Location: 4505 Sherwood Common Blvd

Request: Construct four new office/warehouse buildings totaling 75,600 sq. ft. and associated new parking areas in a single phase on an undeveloped site at Tract. Y-1-A-1-A-1-A-1, Sherwood Common Office Park property

February 3, 2025

Staff Recommendation: Deferral (see Findings 7 and 8)

SITE PLAN

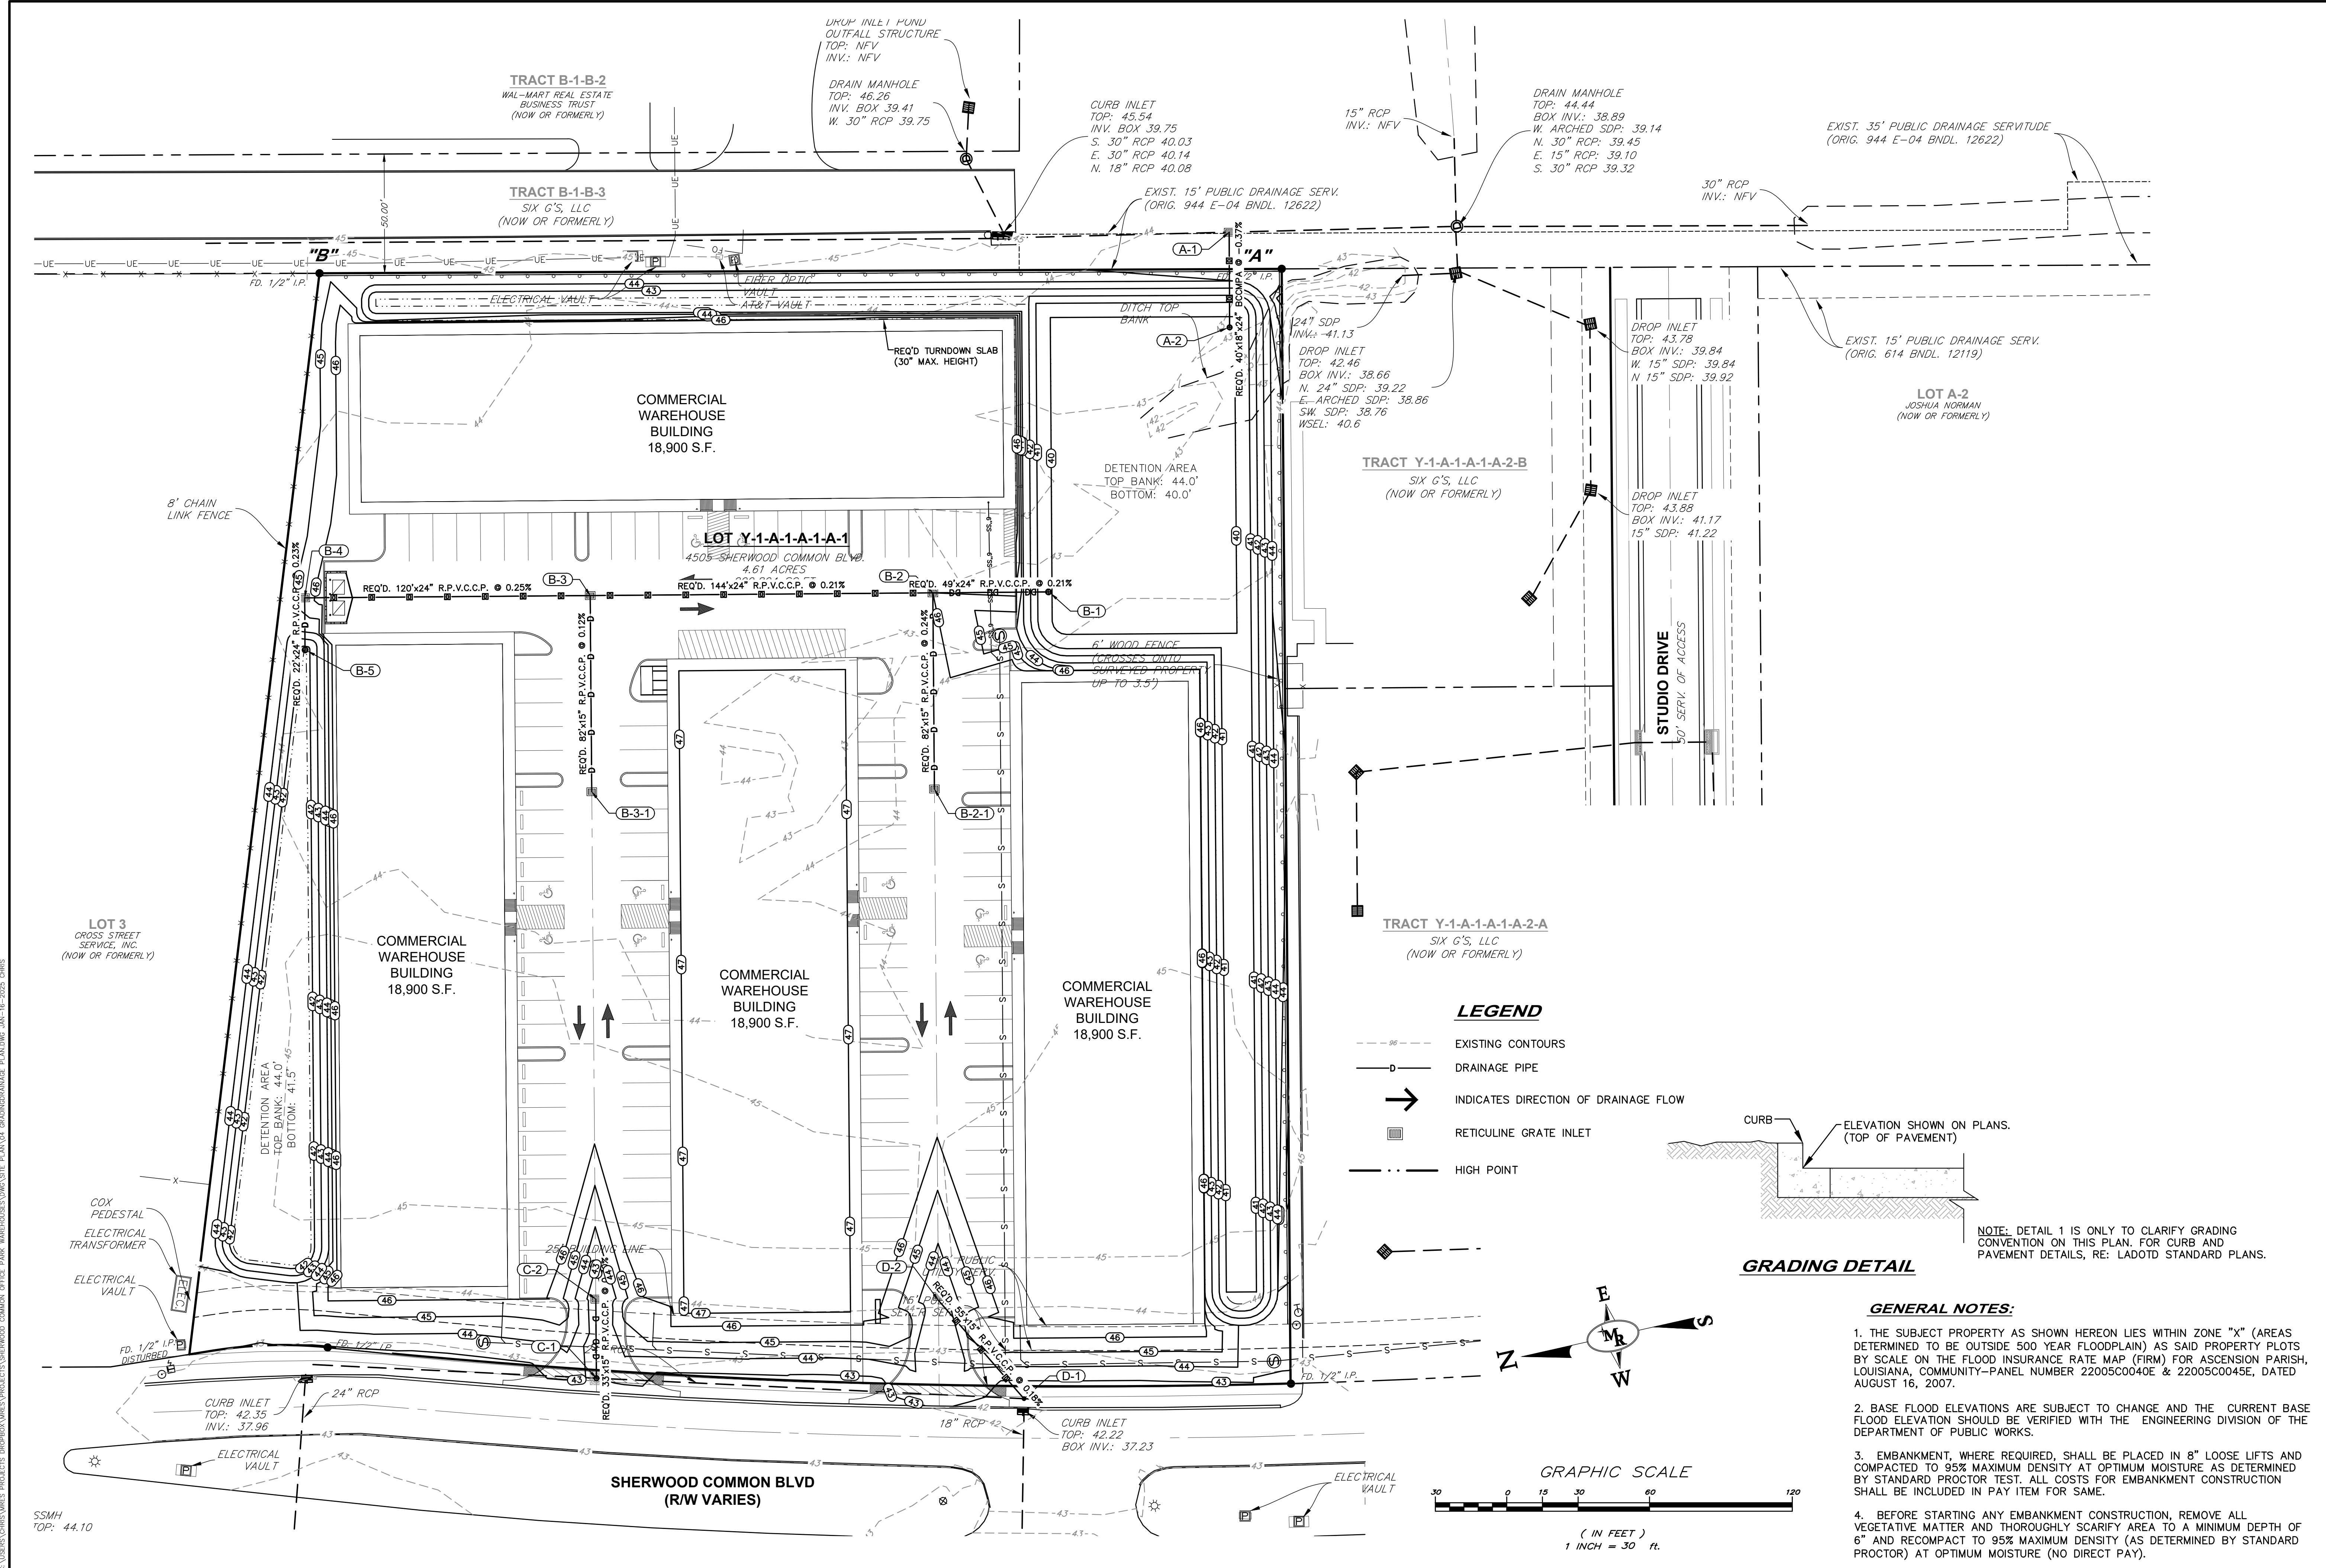
5. The site plan proposes four identical single-story office/warehouse buildings, each with 18,900 sq. ft. GFA. Buildings 2, 3, and 4 are arranged parallel to each other near the street frontage, with two facing south and one facing north. Building 1 is situated at the back of the lot facing west near the east boundary.

6. A total of 121 parking spaces, including 10 ADA spaces, are provided. Bicycle parking racks are provided for 7 bicycles.

7. Two access driveways connect the development to Sherwood Common Blvd, facilitating vehicle circulation throughout the site. As of 1/27/2025, the EBR Transportation Department is still conducting a traffic review, and feedback on the proposed access drive tie-in locations from EBR is pending.

11. The proposed site plan satisfies most technical requirements of the Unified Development Code (Table 1), with minor exceptions and with Findings 7 and 8 above outstanding.

Street yard, landscape strip [18.3.4.C]	Min. 10 ft	25 ft	YES
Parking lot, spaces to a tree [18.3.5]	W/in 100 ft	W/in 100 ft	YES
Parking lot, interior islands [18.3.5]	Every 10 spaces	Every 10 spaces	YES
Parking lot, median islands [18.3.5]	Every 6 rows	N/A	N/A
Screening, utilities [18.4.1]	Shrub	N/A, HVAC on top of buildings	N/A
Sight triangle [18.7.2]	Clear	Clear, but not marked correctly	Likely YES

ARCHITECTURAL
ELEVATIONS

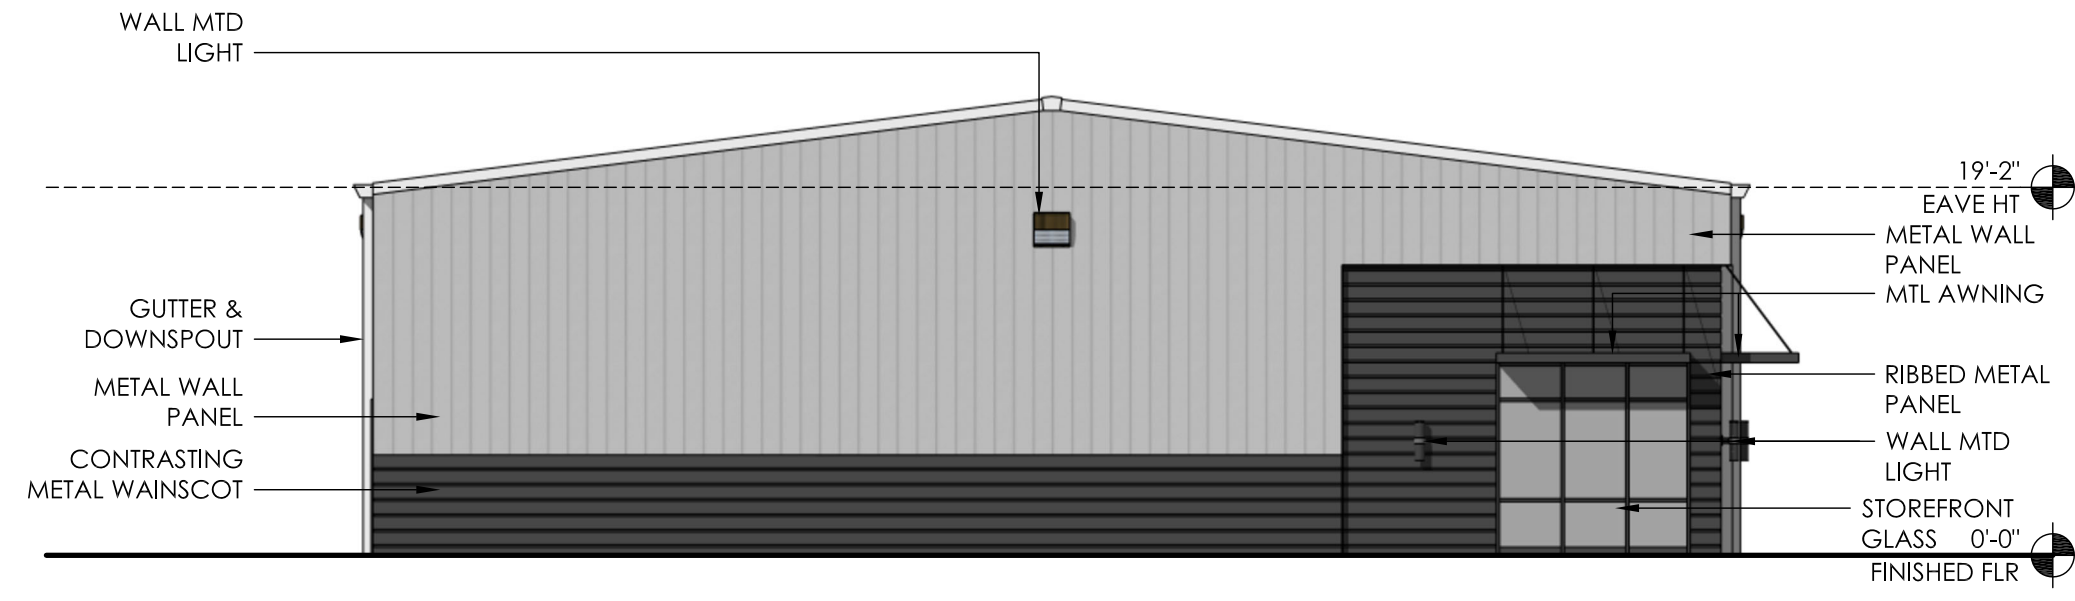
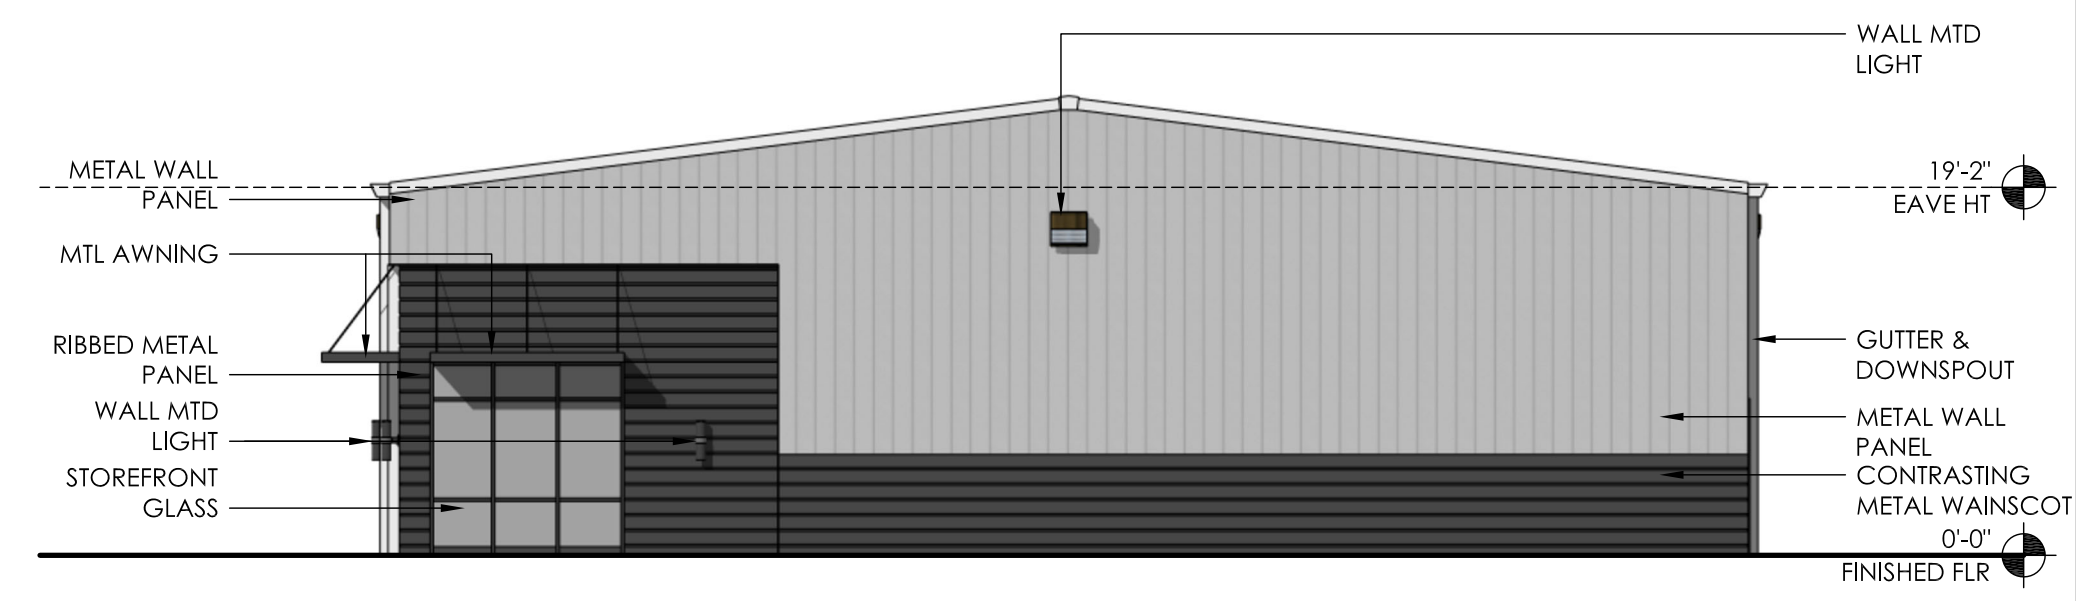
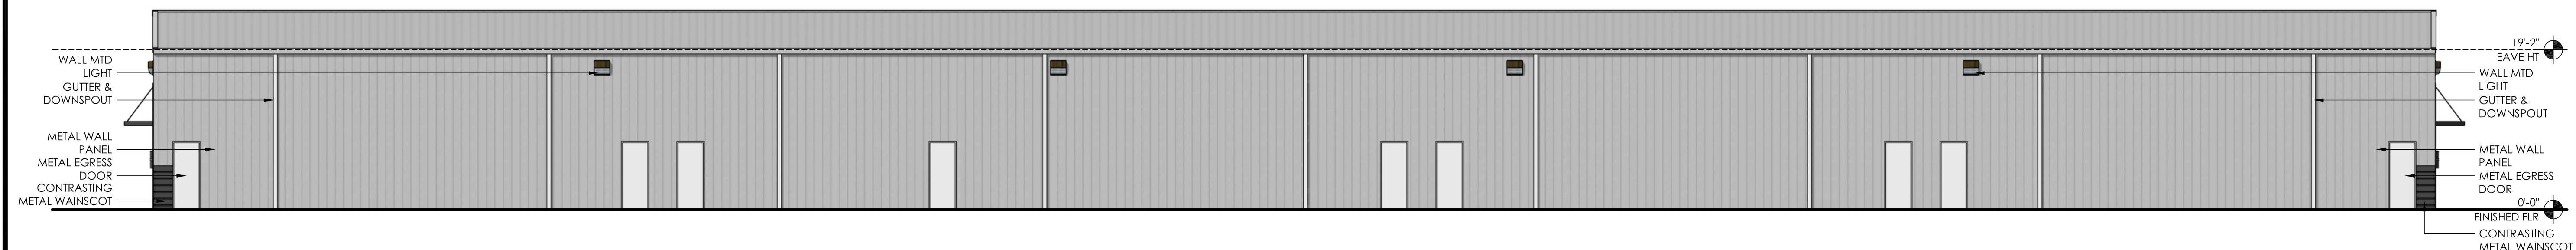
Standard or Guideline [UDC Sec.]	Required	Proposed	Meets?
Suburban Design Standards [10.3.2.E]			
Building design, street-facing wall	Transp. Windows or 5+ Other Elements	Three 70 ft street-facing walls, each with elements: metal wall panel, ribbed metal panel, wall mtd light, storefront glass, metal awning	YES
Site design, pedestrian ways	Min. 8ft-wide to primary entrance	N/A, no primary entrance	N/A
	Sidewalk connection	1 sidewalk connection proposed	Likely YES
Site design, screening, mechanical	From all street frontages	N/A	N/A
Site design, fences, materials	See Code	6 ft. chain-link	YES
Dimensional Regulations [11.2.8]			
Setback, front (Sherwood Common Blvd)	Min. 25 ft	25 ft	YES
Setback, corner side	Min. 10 ft	N/A	N/A
Height	Max. 45 ft	23'-5"	YES
Drainage and Water Quality			
Stormwater Management Plan [15.13]	Yes	Submitted	Not yet
Drainage Impact Study [15.15]	Yes	Submitted	Not yet
Water Quality Impact Study [15.17]	Yes	Submitted	Not yet
